# Service Bulletin

Bulletin No.: P1255A

**Subject:** Changing Outside Rearview Mirrors

**Models:** 2014 Chevrolet Silverado 1500  
2015 Chevrolet Silverado 2500  
2014 GMC Sierra 1500  
2015 GMC Sierra 2500  
Equipped with RPOs DL3, DL8, DE2, DPN, DF2

3802187

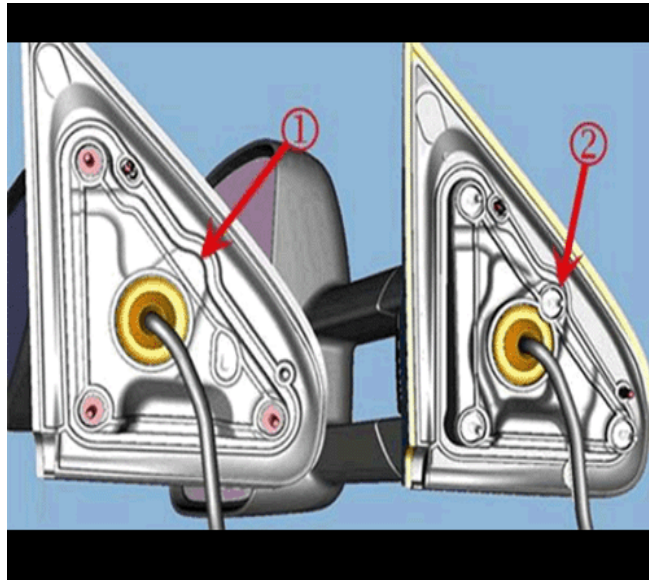
When swapping to the trailer Tow Mirrors, the first thing to know is the installation of the trailer Tow mirrors may require the technician to add an additional mounting hole to the door (See chart below). Non-trailing mirrors only require 3 mounting holes. Trailer tow mirrors require 4 mounting holes.
